SIGIR PA-09-179 OCTOBER 16, 2009

Abattoir (Slaughterhouse) in Qaladze

SUBJECT: Report on the Abattoir (Slaughterhouse) in Qaladze, Sulaymaniyah Province, Iraq (SIGIR Report Number PA-09-179)

Abattoir (Slaughterhouse) in Qaladze Sulaymaniyah, Iraq

Site Photo 16. Correctly designed/placed ceiling beam Site Photo 17. Wall expansion joint incorrectly filled with plaster

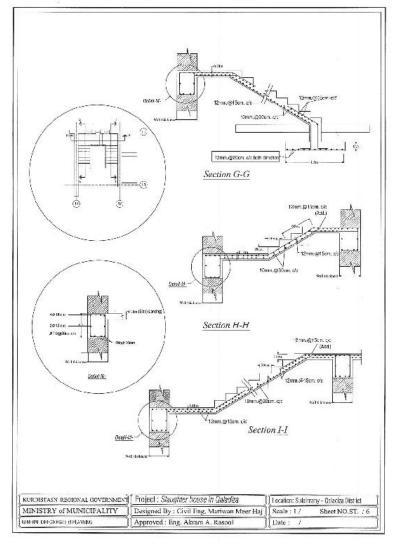
First, the facility's expansion joint system, which is to protect the structure from thermal variations, was incomplete. The expansion joint was correctly designed/placed for the ceiling beams, columns, walls, and roof slab; however, the joint was incorrectly finished and/or not finished at all for the floor and parapet (Site Photos 16-19). An expansion joint was designed and constructed for the wall columns; however, instead of placing the proper expansion joint material inside the joint, the contractor plastered inside it instead. The absence of an expansion joint for the parapet has resulted in a vertical crack. SIGIR found no expansion joint system for the facility's exterior walls. Considering that these walls are exposed to excessive heat in the summer and snow in the winter, a welldesigned expansion joint system was warranted. Additionally, sealed joints prevent moisture, dust/dirt particles, and crawling insects from entering the living spaces. Consequently, an expansion joint system promotes structural safety for the building and also provides a better living environment for the occupants.

expansion joints

Site Photos 18 and 19. Absence of expansion joint for the floor (left) and parapet (right)

During the site visit, SIGIR identified these deficiencies to the KRO representatives. They readily agreed to the need for internal and external expansion joints and discussed the issue directly with the contractor's on-site representative. The contractor's representative agreed to provide a corrective action plan for the expansion joints to the KRO representatives.

The KRO representatives immediately followed up with the contractor to take corrective actions relating to the deficiencies that SIGIR identified during the site visit. By September 2009, the contractor had already corrected the stair issue and was working on the expansion joints. The contractor provided photographic documentation to support his claim of corrective actions taken. The photographs show measurements of stair heights and also the initial construction of an exterior expansion joint (Site Photo 23).

Figure 2. Design submittal for concrete stair unit (Courtesy of USACE KRO)

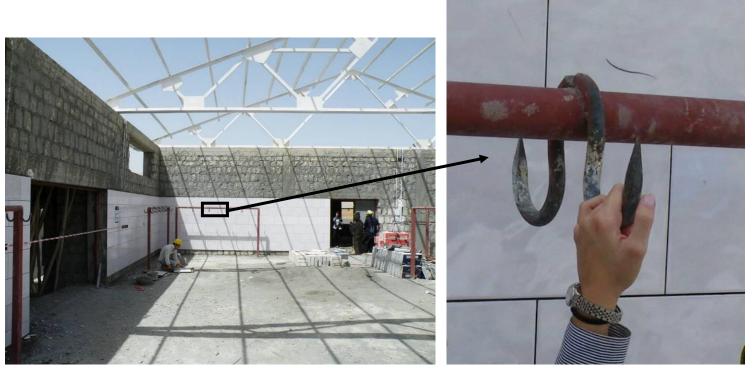
Second, SIGIR identified a tripping hazard inside the facility (Site Photo 20). The risers for a reinforced concrete stair unit are inconsistent and not within the dimensional range specified by the building code and detail shown on the design submittal (Figure 2). Specifically, the first step is only 7 centimeters high, instead of the required 17 centimeters. The site condition of the stair unit does not reflect the original design drawing. In order to provide a safe working environment, this tripping hazard needs to be corrected.

Height of first step is significantly lower than required

Site Photo 20. Bottom step poses tripping hazard

With regard to the tripping hazard, KRO representatives stated that a quality assurance (QA) daily report had previously identified this problem and that the KRO QA representative was working with the contractor on a corrective action plan.
